# ADDENDUM No. 1

## ITB No. 4525

### CREST BUENA VISTA WASHINGTON WATER MAIN PROJECT

SCALE PLAN: 1" = 20'  
DRAWING NO. 2016029-13  
SHEET NO. 13 OF 46

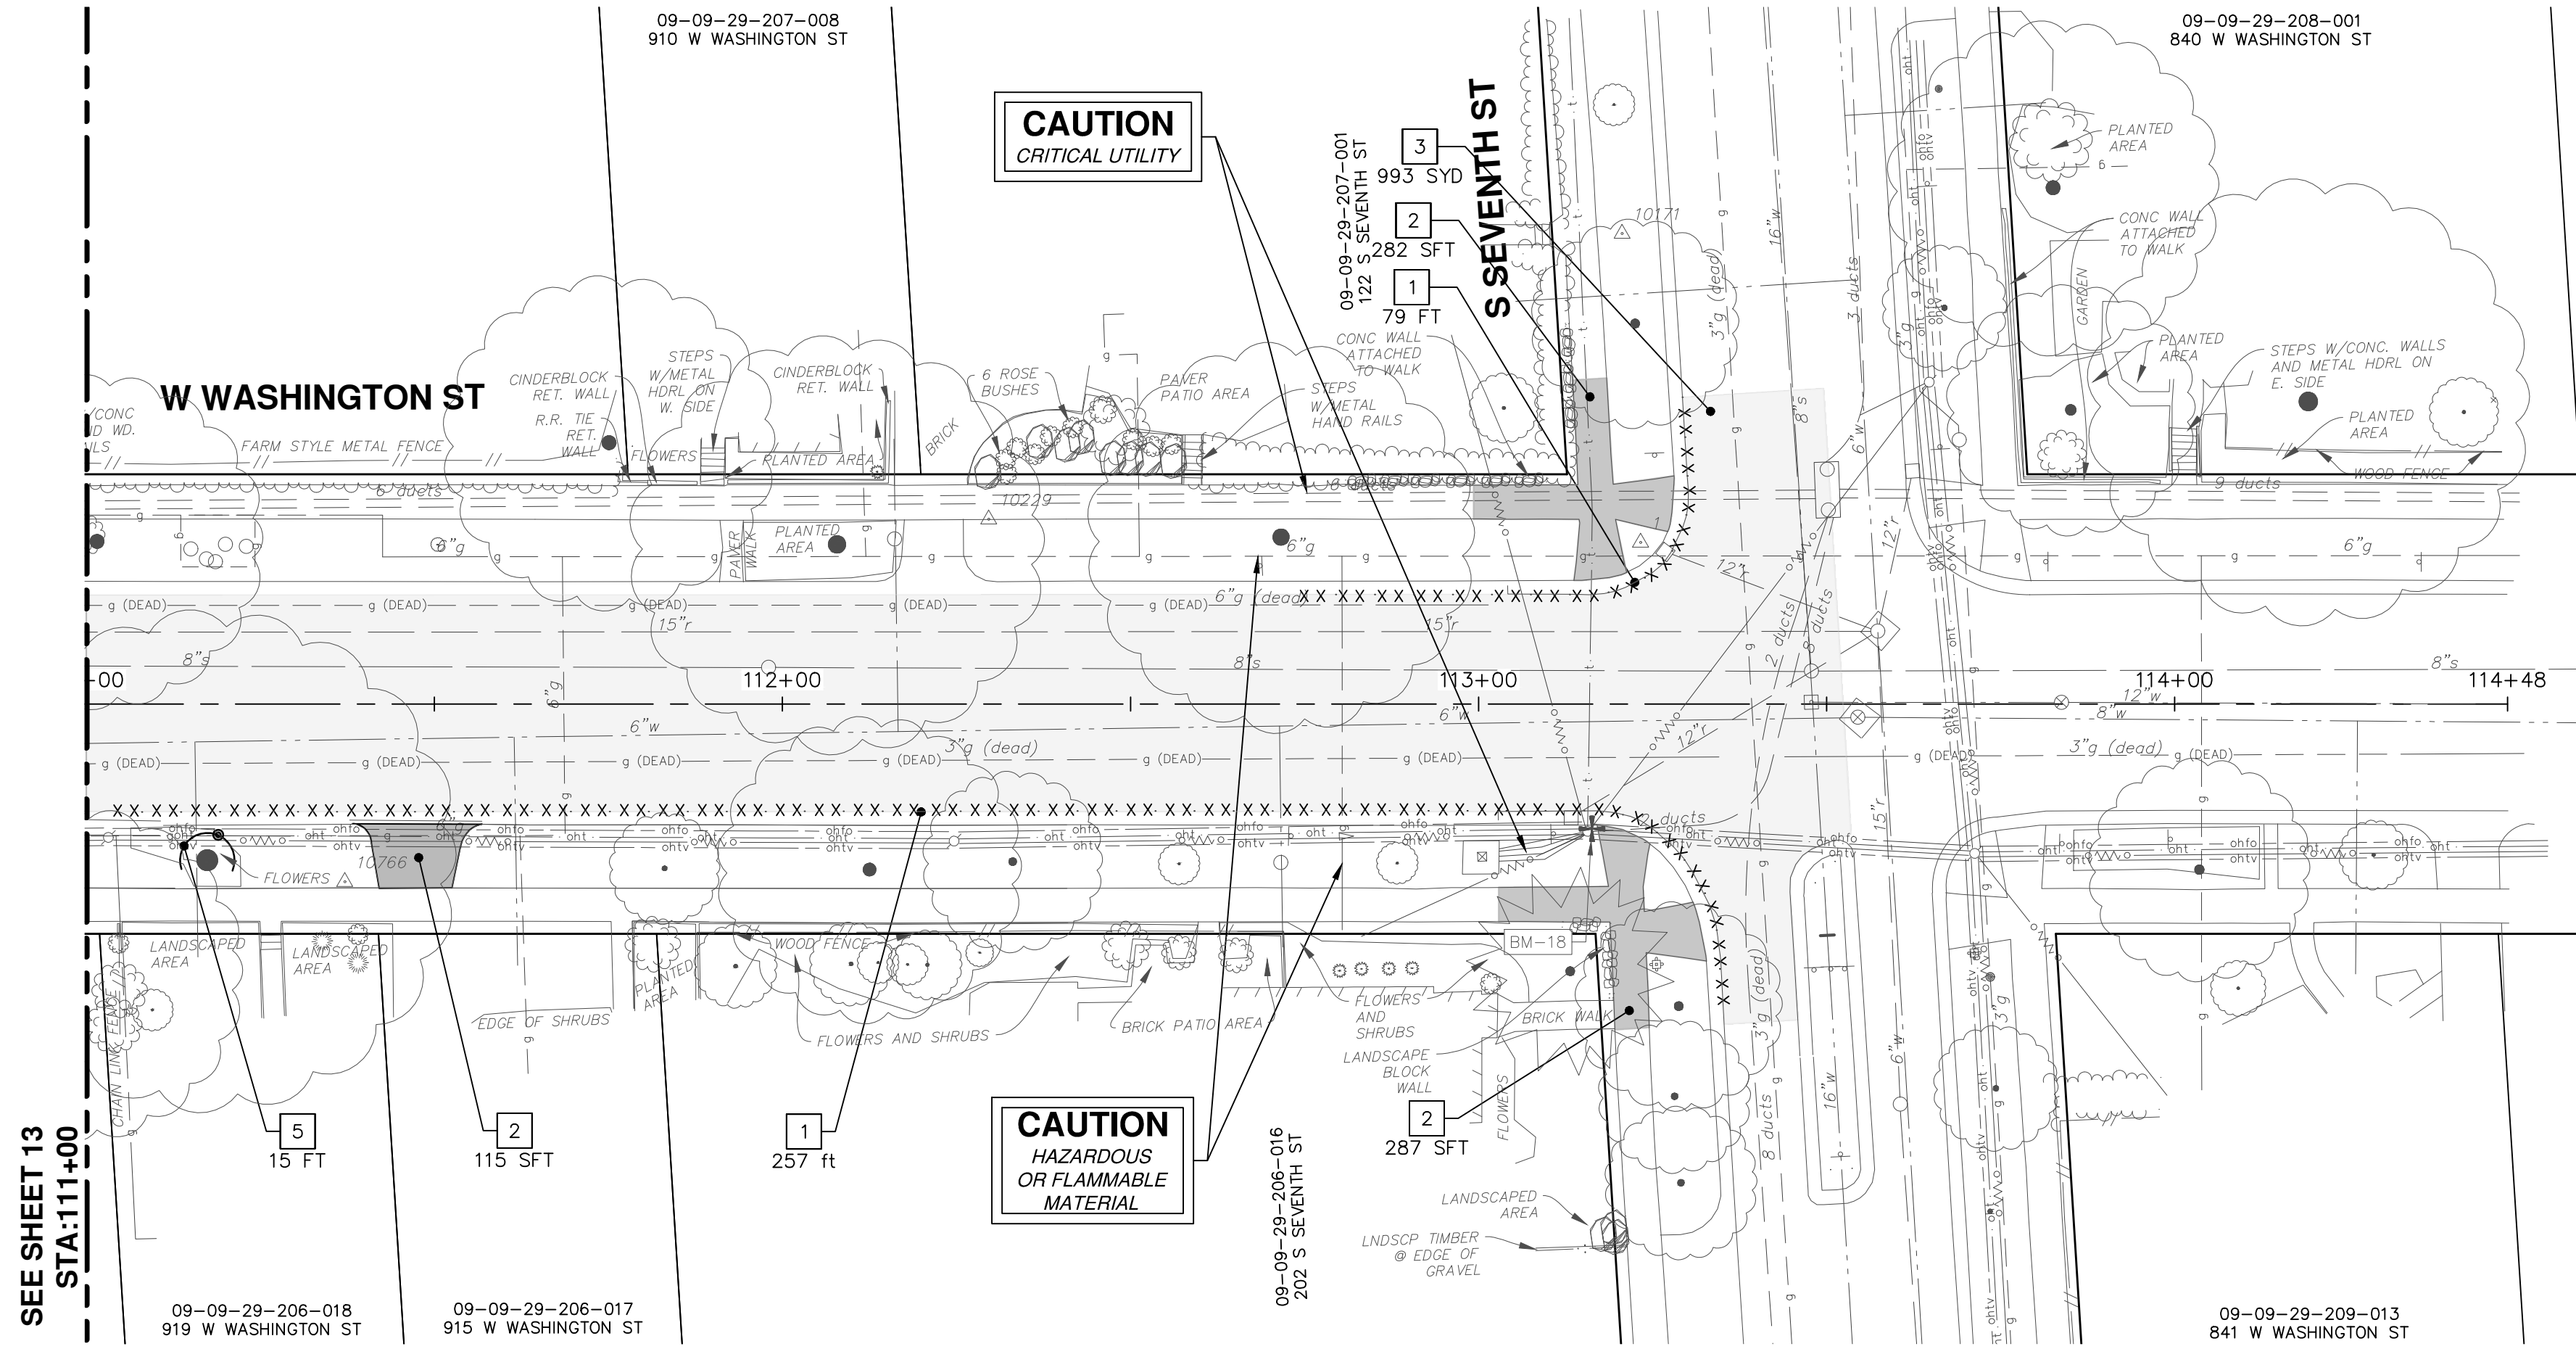
On plan sheet 13, multiple curb & gutter removals and driveway removals from Washington's STA 0+00 to 10+00 were eliminated.

SHEET No. **15 OF 46**

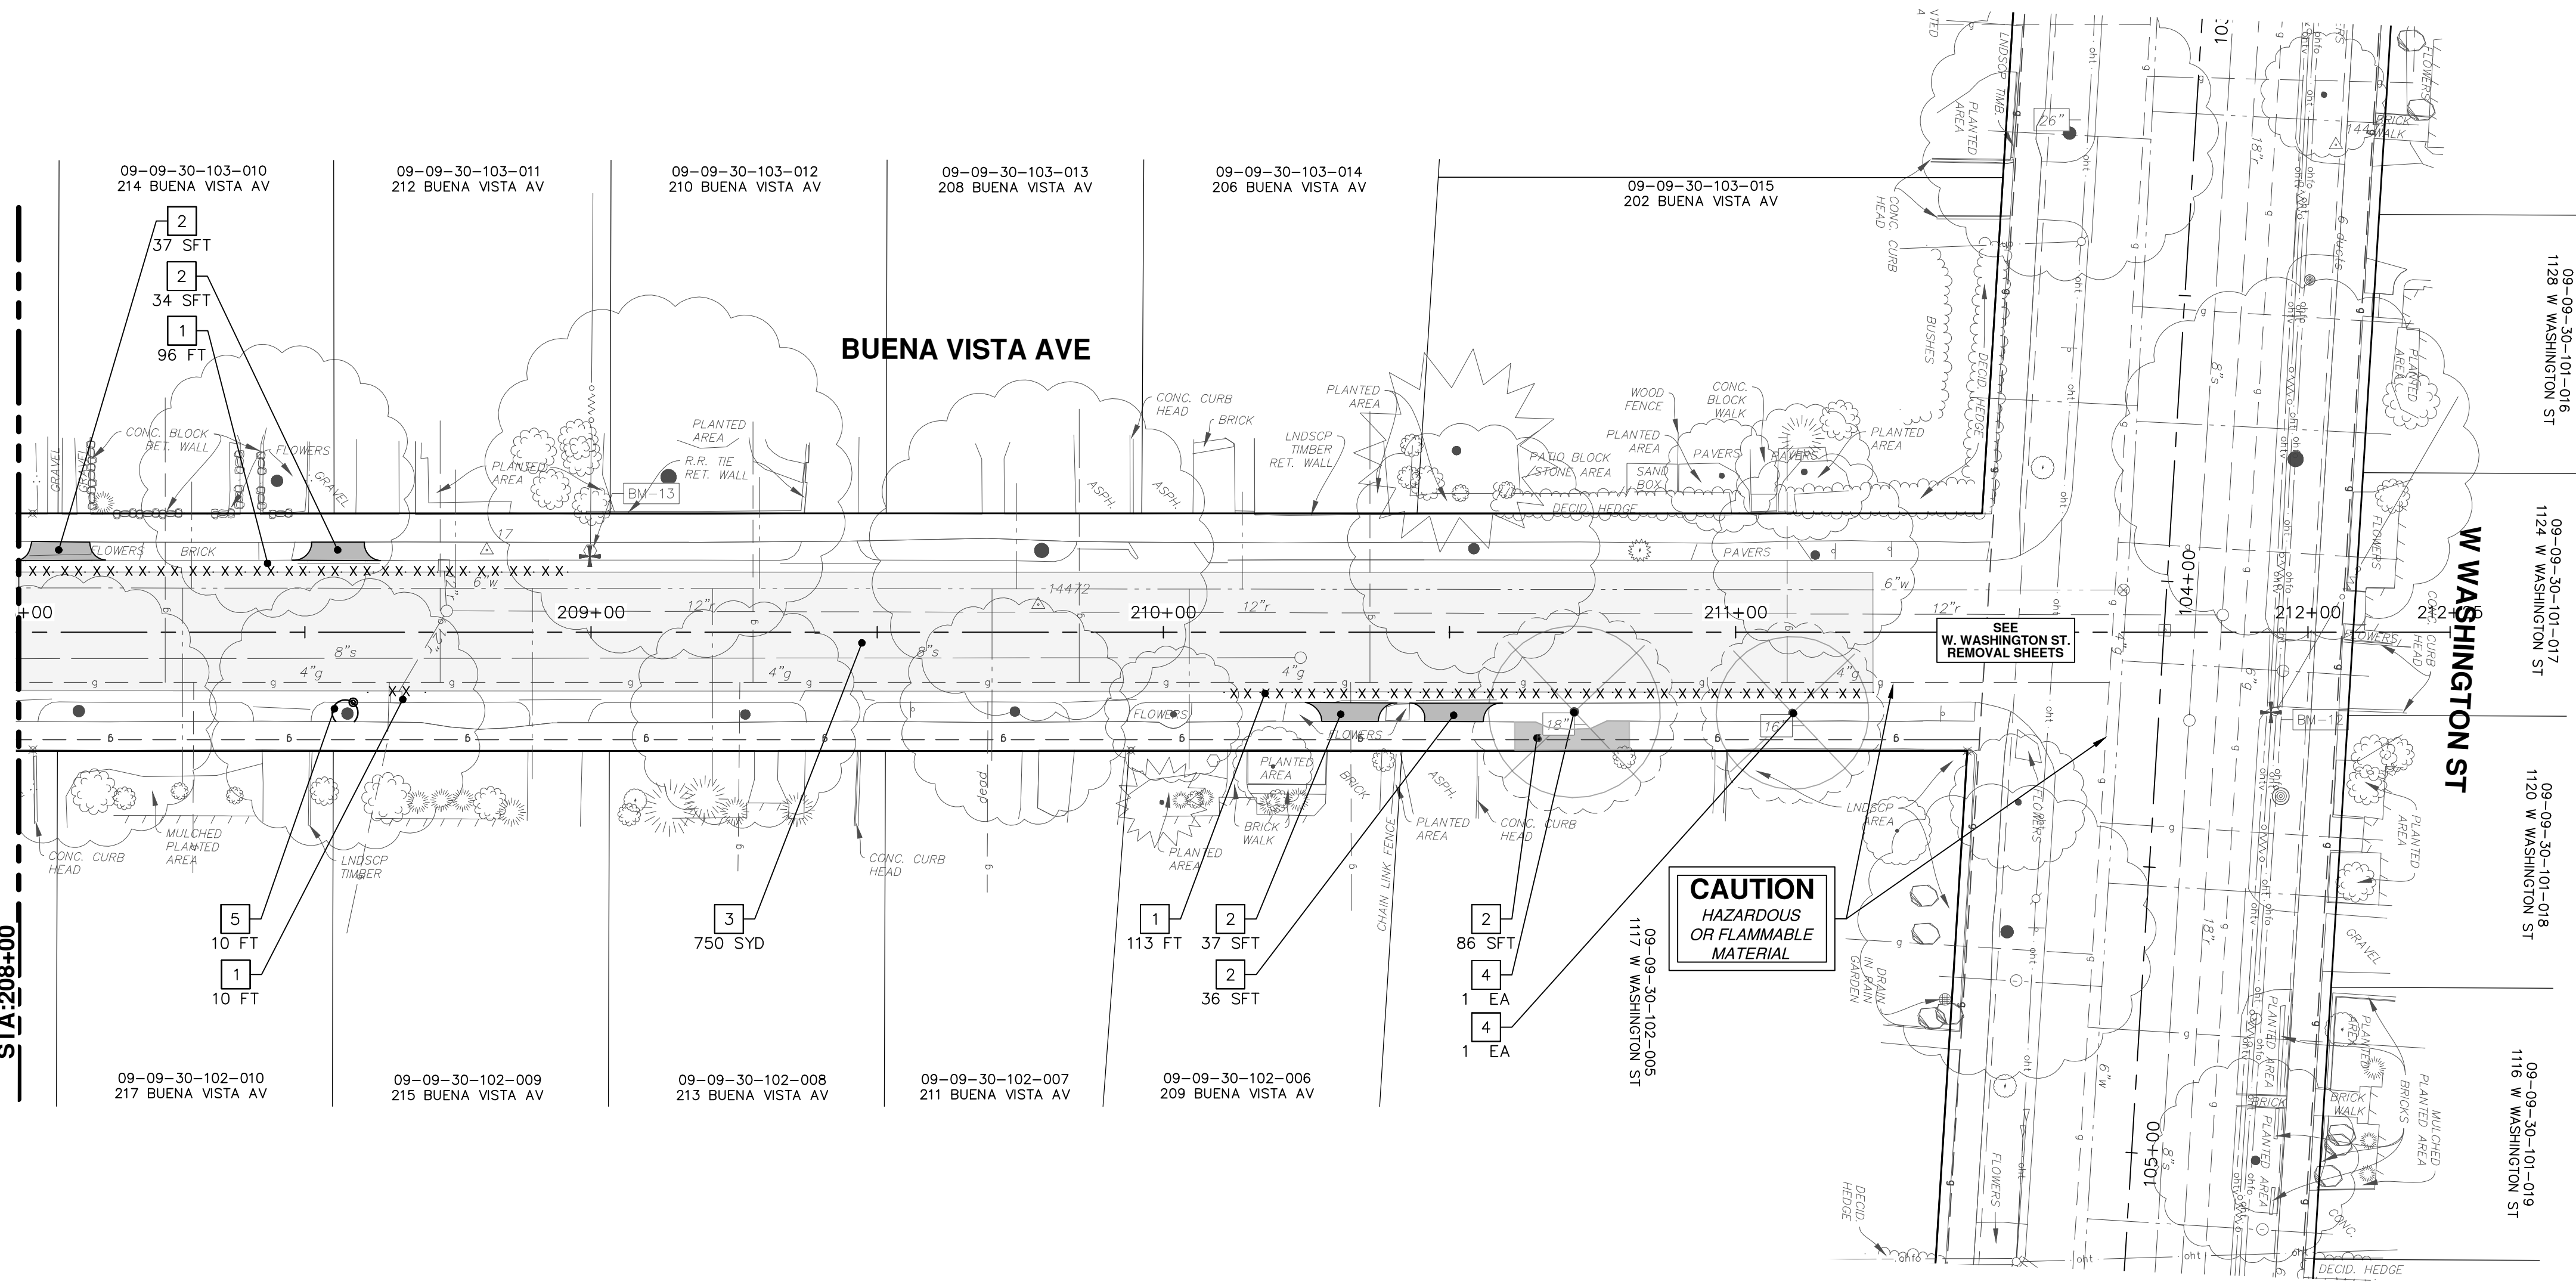
On plan sheet 15, sidewalk removal was added to the corner in Buena Vista.
